7.2 Reactor Protection (Trip) System (RPS)—Instrumentation and Controls

The information in this section of the reference ABWR DCD, including all subsections, tables and figures, is incorporated by reference with the following departures and supplements.

STD DEP T1 2.3-1 (Table 7.2-1, 7.2-2, Figures 7.2-2, 7.2-6, 7.2-9, 7.2-10)

STD DEP T1 3.4-1 (Figures 7.2-2, 7.2-9, 7.2-10)

Figure 7.2-2 Reactor Protection System Equipment Arrangement (From Sensors Through Trip Actuators)

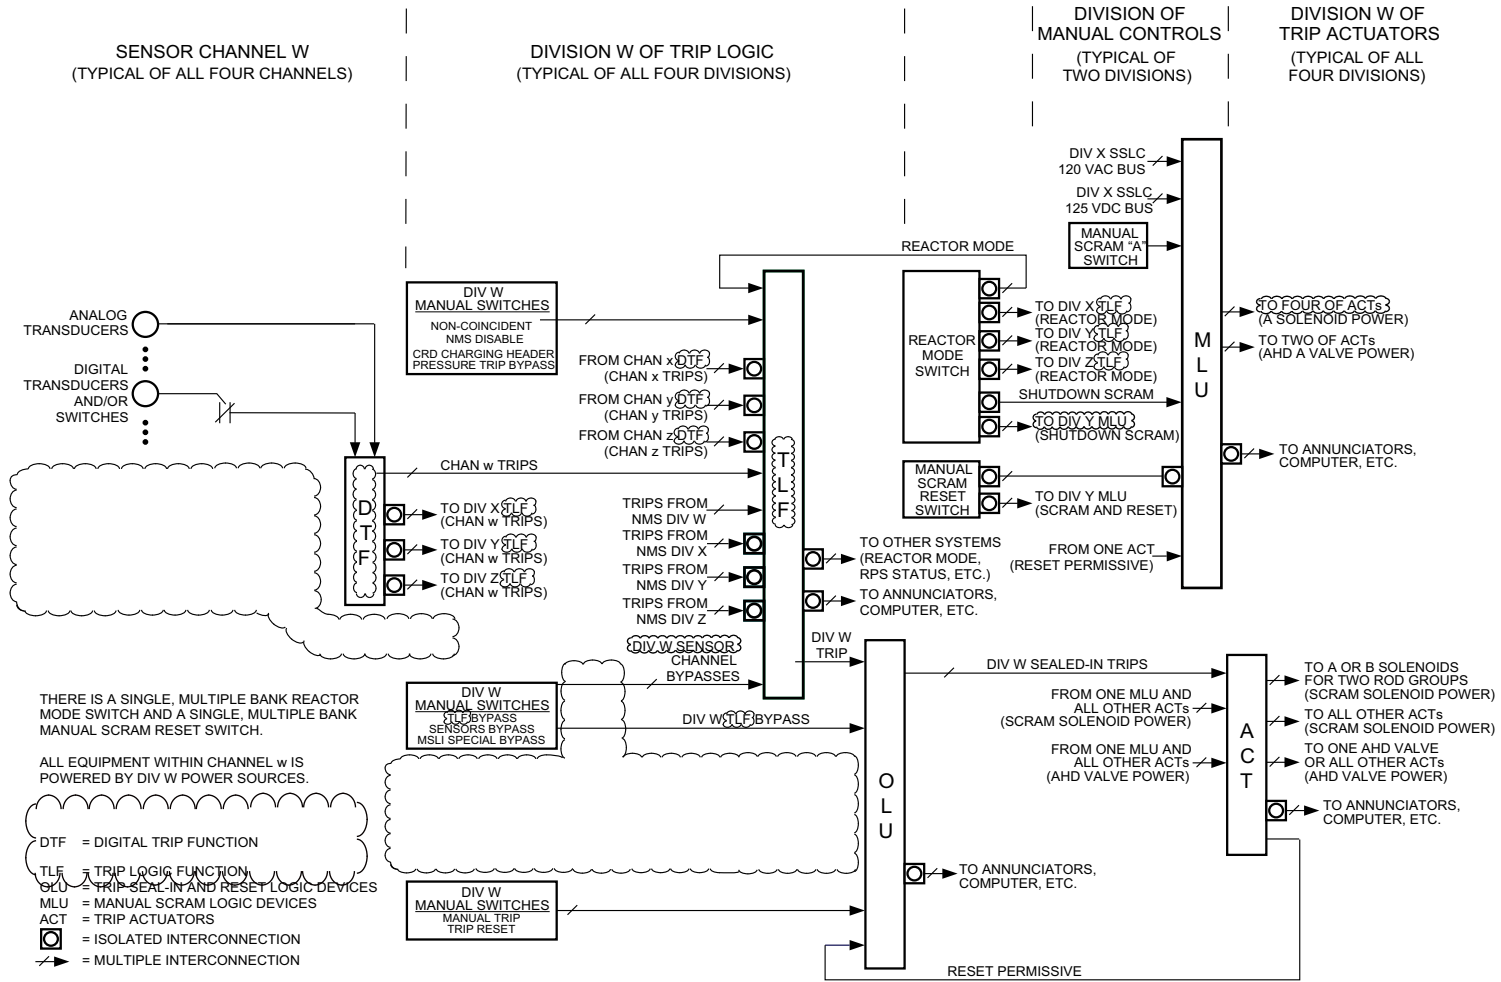
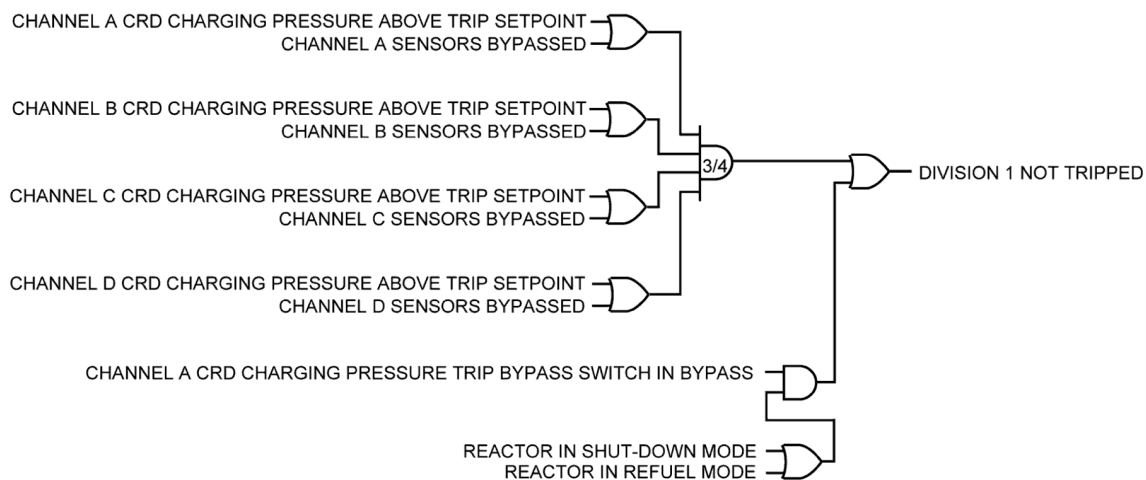
The RPS equipment is divided into four redundant divisions of sensor (instrument) channels, trip logics and trip actuators, and two divisions of manual scram controls and scram logic circuitry. The sensor channels, divisions of trip logics, divisions of trip actuators and associated portions of the divisions of scram logic circuitry together constitute the RPS scram and air header dump (backup scram) automatic initiation logic. The divisions of manual scram controls and associated portions of the divisions of scram logic circuitry together constitute the RPS scram and air header dump manual initiation logic. The automatic and manual scram initiation logics are independent of each other. RPS equipment arrangement is shown in Figure 7.2-2.

Equipment within a sensor channel includes primarily sensors (transducers or switches), ~~multiplexers and digital trip modules (DTMs)~~ trip functions (DTFs). The sensors within each channel monitor plant variables (Subsection 7.2.1.1.4.2) ~~and send either analog or discrete output to remote multiplexer units (RMUs) within the associated division of Essential Multiplexing System (EMS) the DTF.~~ Each division of the EMS performs analog to digital conversion on analog signals and sends the digital or digitized analog output values of all monitored variables to the DTF within the associated RPS sensor channel. The ~~DTM DTF~~ in each sensor channel compares individual monitored variable values with trip setpoint values and for each variable sends a separate, discrete (trip/no trip) output signal to all four divisions of trip logics.

Equipment within a division of trip logic includes primarily manual switches, ~~bypass units (BPUs)~~ bypass interlock functions, trip logic units functions (TLUs/TLFs) and output logic units (OLUs). The various manual switches provide the operator means to modify the RPS trip logic for special operation, maintenance, testing and reset. The ~~BPUs~~ bypass interlock functions enforce restrictions on bypassing multiple divisions of related functions. The bypass interlock functions perform bypass and interlock logic for the channel sensors bypass, main steamline isolation trip special bypass and division trip logic unit bypass. These three bypasses are all manually initiated through individual

Figure 7.2-6 Division 1 Trip Logic

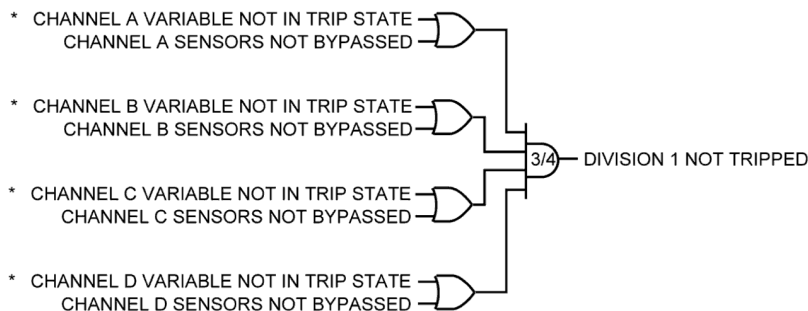
(4) ~~Process Radiation Monitoring (PRM) System (Figure 7.2-6)~~ Not Used

~~*High Main Steamline Radiation Trip (Figure 7.2-6)*~~

~~*A high main steamline radiation trip will occur in each division of trip logic when a main steamline radiation trip condition exists in any two or more unbypassed sensor channels. There are no operating bypasses associated with this trip function.*~~
